COUNTY ADMINISTRATOR'S OFFICE

November 17, 2017

Re: **2017 Addendum to Water Quality Permit, Rosemont Copper Project ACOE
Application No. SPL – 2008-00816-MB**

Figure 1. In red, areas of former mine-related activities based on cultural resource surveys. Drill holes in yellow. Location of stock tank removals shown in green and are approximate.

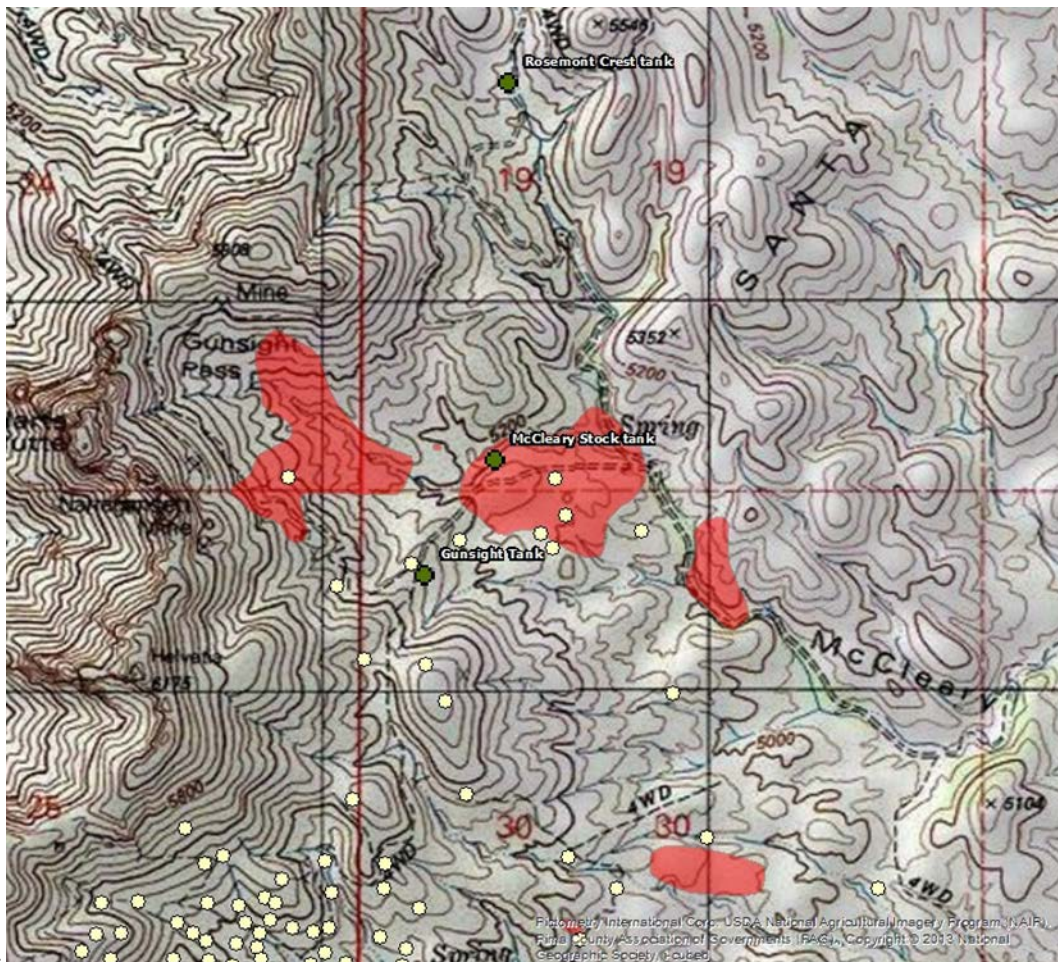
Upstream land surface disturbances may cause or contribute to surface water quality exceedances. A paper from the Journal of Geochemical Exploration (Hawkes 1976) documents the sources of copper anomalies in sediments tributary to Cienega Creek. The anomalous values are identified as having sources in Barrel Canyon, and “old copper prospects” in McCleary Canyon. These areas have been affected by many previous mine-related activities. As shown in the above figure, two of the proposed stock tanks for modification is in an area where cultural resource surveys indicate historic mine-related activities.

Hubday (2015) data show that under current conditions, which include numerous mining features and land disturbance upstream, base flows of springs are of good quality. Elevated levels of dissolved copper, and total lead and copper have been consistently observed in stormwater at monitoring site PSW-4. Upstream spring flow met the livestock standards (Tetra Tech memorandum dated May 5, 2009). Would release of stored sediment increase ambient metal concentrations? Further study is warranted before the state can draw a conclusion that existing uses will not be impaired by the dredge-and-fill activities upstream, which include the stock tank removals. The stock tanks in the upper McCleary watershed are located below old mining claims which were historically worked (Figure 1).

Figure 2. This aerial photograph, dated April 2016, shows intermittent stream flow downstream of McCleary diversion dam. Additional spring and in-stream flow uses occur upstream.

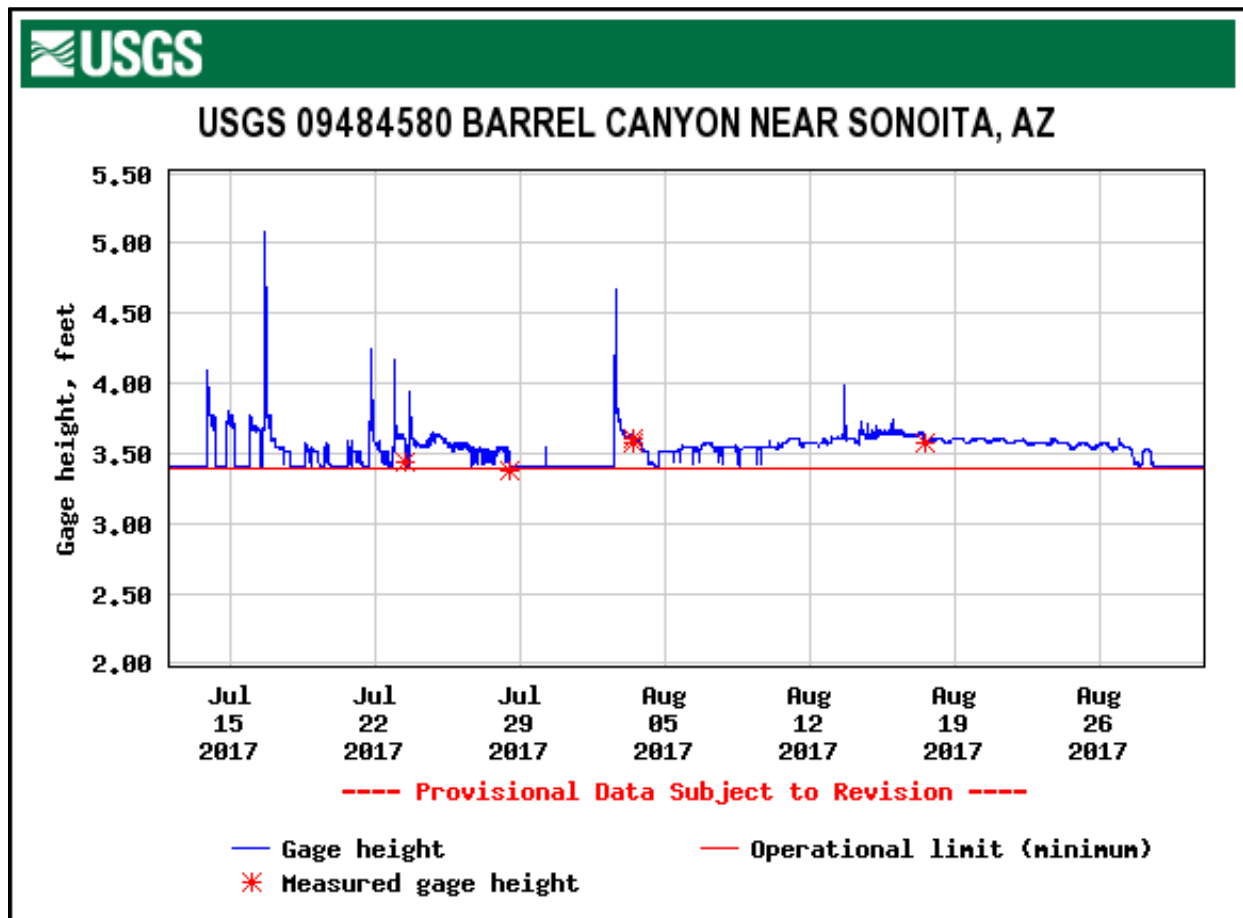
The Section 404(b)(1) Alternatives Analysis recognized that McCleary Canyon has intermittent flow on page 4, where they cite “occasional spring flow within short reaches of McCleary Canyon and other drainages” and “the highest quality (read “higher vegetation density”) riparian habitat was found in a relatively short, moister reach in upper McCleary Canyon...”

Intermittent flow in McCleary includes two discharging springs and streamflow upstream and downstream of a diversion dam near latitude 32.3344 degrees north and 110.972 degrees west (Figure 2). Errol Montgomery and Associates measured flow at the McCleary dam during every month for two consecutive years, establishing the perennial nature of the discharges below the dam. In 2010, a pipe was installed at the dam to feed cattle troughs. (See Rosemont-67 East Side Information Summary of Groundwater Level Measurements for Wells, Piezometers and Drill Holes and Monitoring Date for Seeps and Springs.) Water quality samples were obtained by Montgomery and Associates during May and June, as well as other months of the year, again demonstrating the presence of perennial or near-perennial water in this stream.
